Meeting Date:
December 8, 2025

Location:
Robinson Field Park
2600 Ravenna Street

Request:
Major Site Plan

Hudson Planning Commission	SITE PLAN REVIEW – ROBINSON PARKING AREA
Case No. 25-1428	December 8, 2025

Figure 3

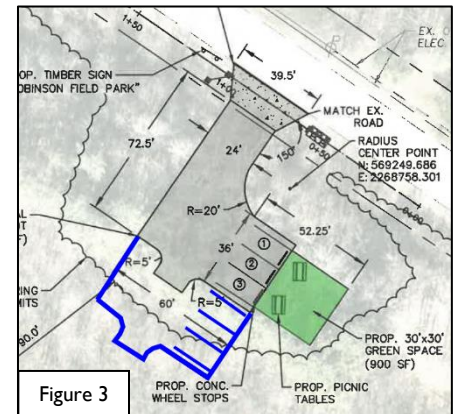
Staff notes Section 1207.12e)(5) states *Landbanking of parking area for potential future use is encouraged*. To ensure parking is not overbuilt but provide the flexibility for future expansion, the Planning Commission could consider approving landbanked parking spaces with this submittal. Staff recommends an expansion of 3 additional spaces be considered as depicted in Figure 3.
